RETROFIT
To Qualify For
Type B Std.

REVISIONS		GAMMA INDUSTRIES BATON ROUGE, LA.	
RETROFIT	5-5-78	ASSEMBLY GAMMATRONS	
		SCALE:	DRAWN BY J.R.G.
		DATE: 7-17-70	REVISED:
		20A, 50A, 100A, 200A	
		20, 50, 100, 200

DETAIL # 1

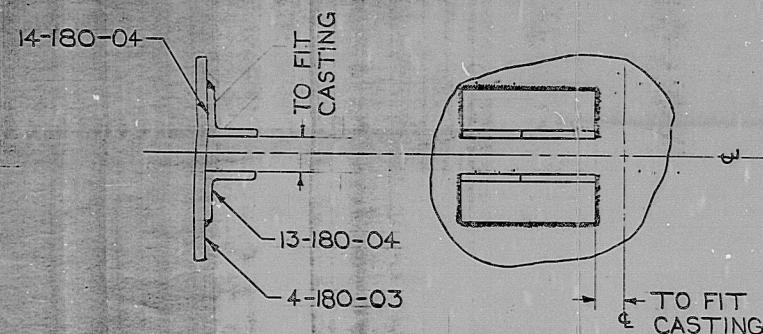
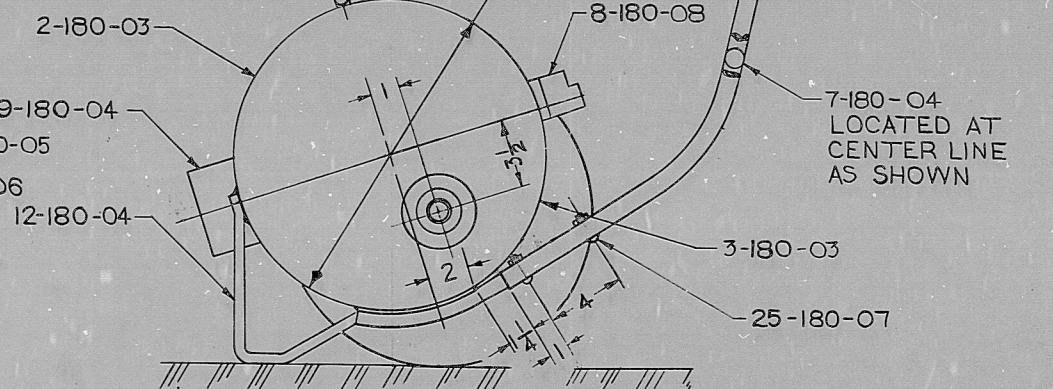
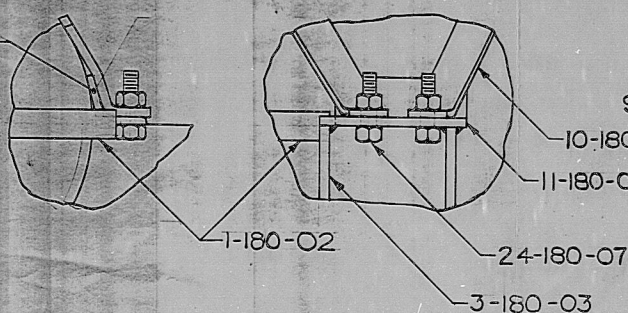
CLEARANCE
BETWEEN
CASTING AND
180-06 BEND
180-06 TO
CASTING AS
SHOWN.
